BROOKVALE STRUCTURE PLAN

<Replace existing Figure 1 Brookvale Structure Plan with the following>

Figure 2A – Typical Road Section (Davidson Road)

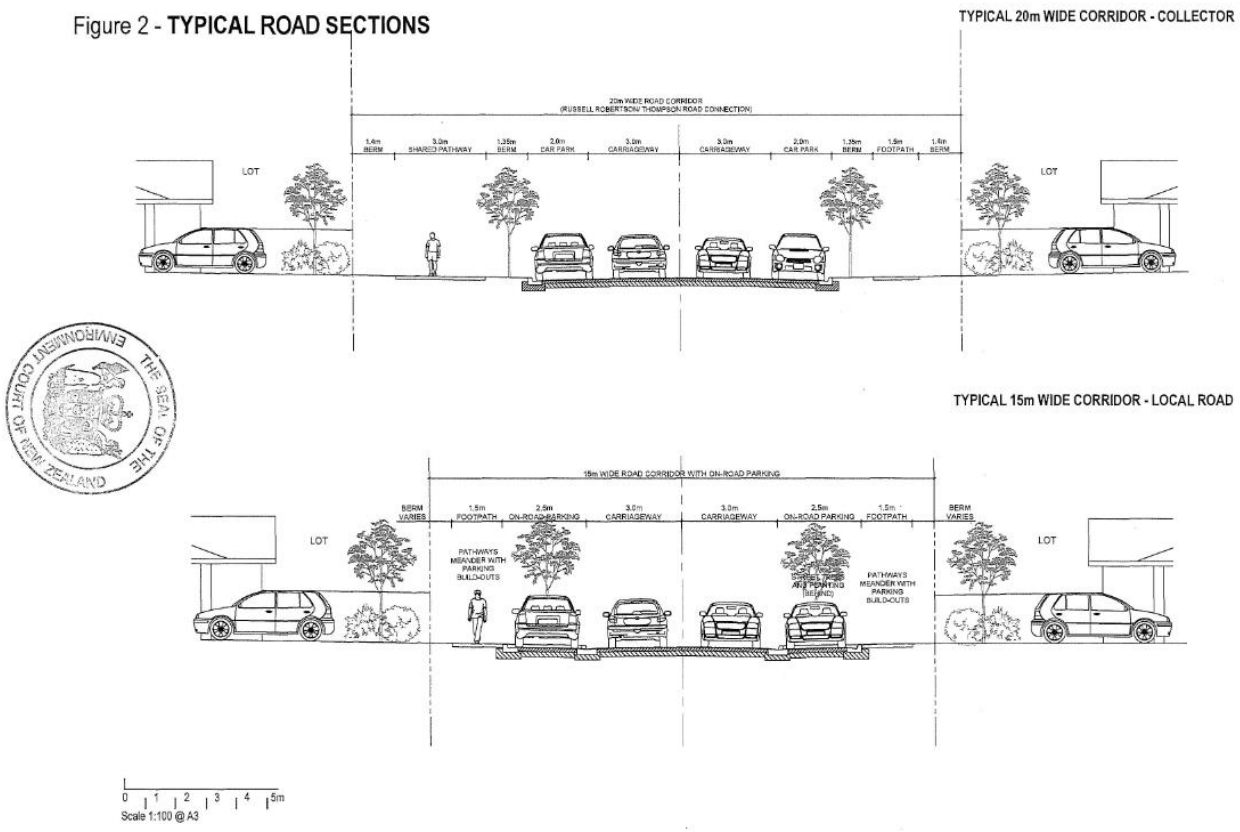
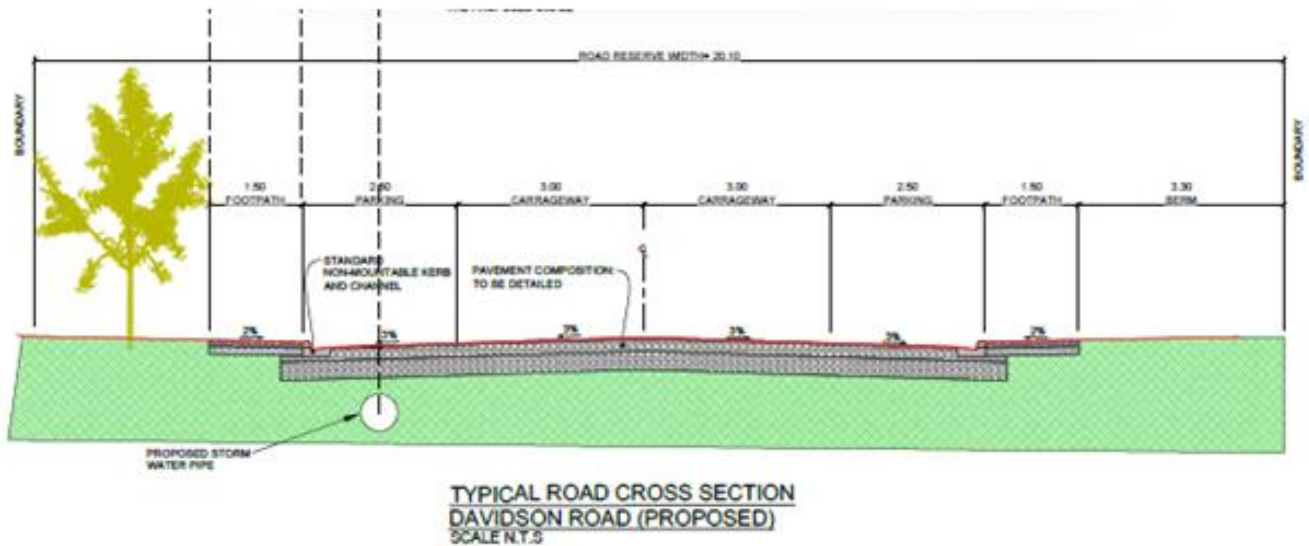
The upgrades to Davidson Road shall generally be provided in accordance with the indicative cross-section and plan in Figures 2A and 2B unless otherwise approved by HDC.

- Provision of a footpath on both sides of the road;
- Provision of on-street carparking on both sides of the road, in indented parking bays, cycle lane/s and a footpath;
- Incorporation of traffic calming measures;
- Incorporation of 'low impact design' stormwater features within the street design and streetscape as a whole;
- Street lighting shall be deflected downwards towards the road and footpaths to reduce the impacts of lighting on surrounding properties; and
- Street trees shall be planted in an avenue style in the road berm areas. Plans outlining the species proposed [1], spacing of trees and location within the berm area shall be provided with any application for subdivision.
